Appendix A

AGENCY AND PUBLIC COMMENTS AND RESPONSES ON THE DRAFT PROGRAM ENVIRONMENTAL IMPACT REPORT

*Airport Master Plan
Program EIR*

Figure 1 – 100-Year Flood Events for Existing Conditions and Projected 2100 Sea Level Rise Scenario (Figure 18.2 from the Plan Santa Barbara)²

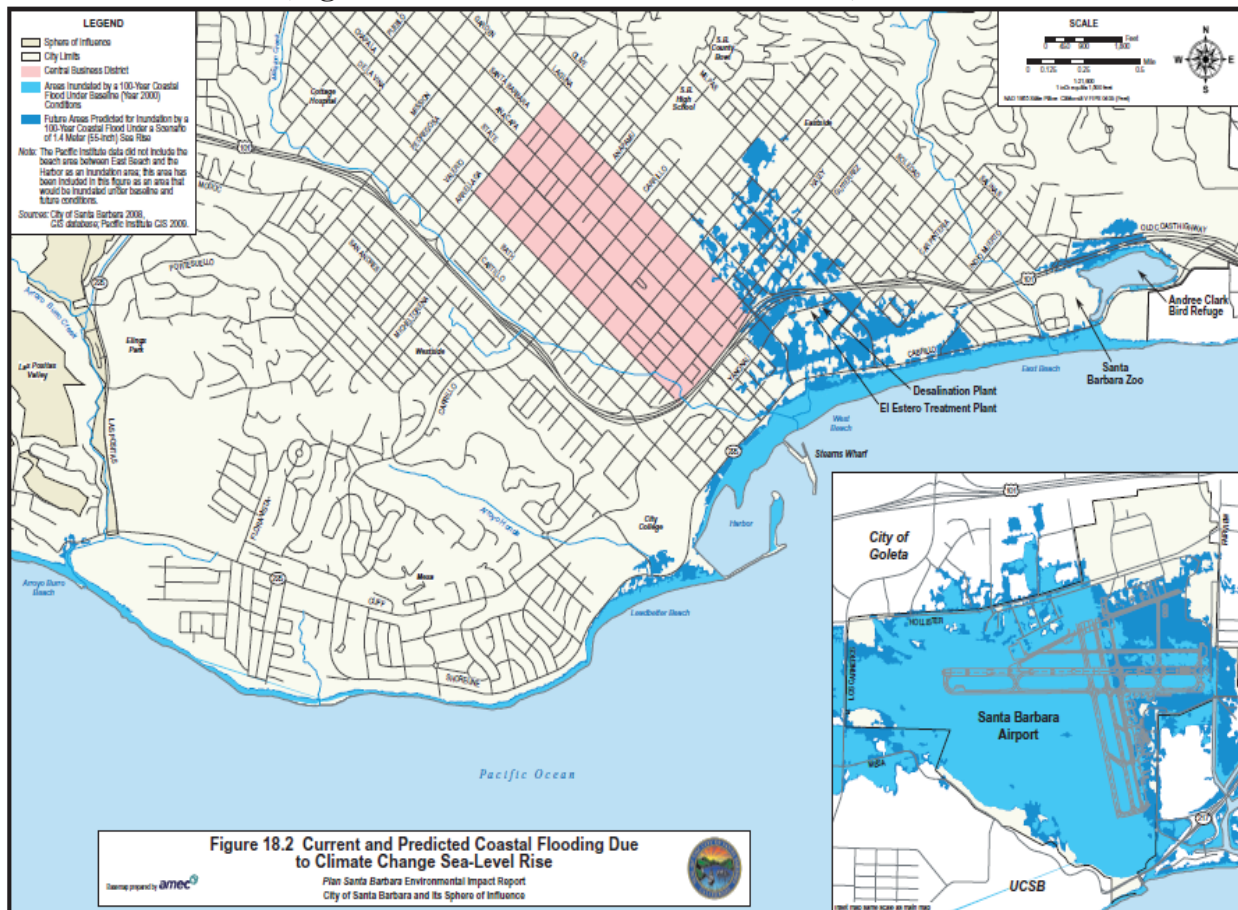
OCEAN-3: This comment discusses the sea level rise predictions of the 2010 Santa Barbara Sea-Level Rise Vulnerability Study, including Figure 18.2 from the Final EIR on *Plan Santa Barbara General Plan Update*. This figure shows the extent of flooding at the Airport if 55 inches (1.4 meters) of sea-level rise occurs by the year 2100, which is near the high end of the State's projections in the City Sea-Level Rise Vulnerability Study.

Response: Thank you for your comments. The City believes these concerns have been adequately addressed under Section 4.5, Hydrology and Water Quality (see Recirculated Draft EIR).
